**AMENDMENT/ADDENDUM No. 1**

**Solicitation Number:** 2021-49RF

**Description:** Gas Line & HVAC Replacement at Forestbrook Middle School

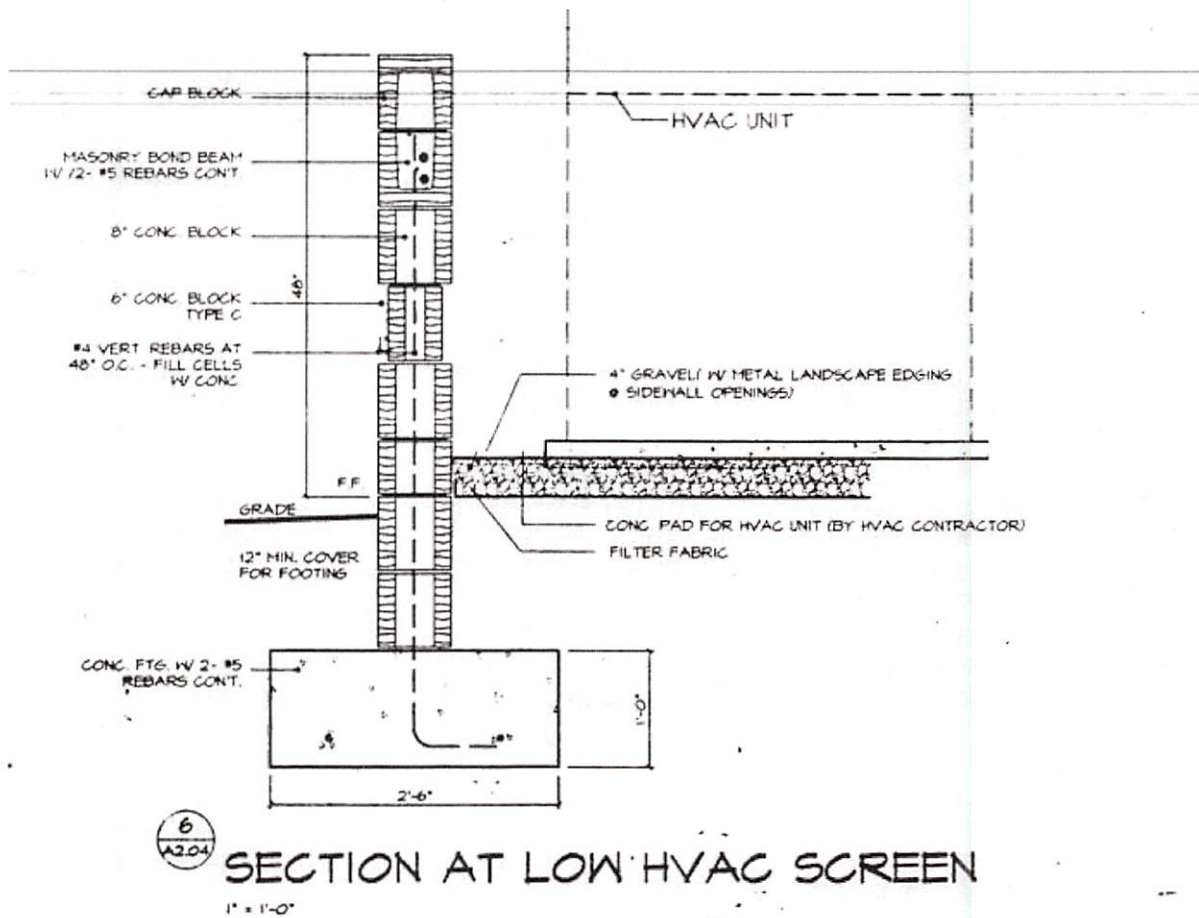
7. Please refer to the masonry detail from the original drawings for construction requirements of the new walls shown on the contract documents as provided below. For the purposes of bidding the project the contractor shall assume that the original colors (or one closely matching) will be available.
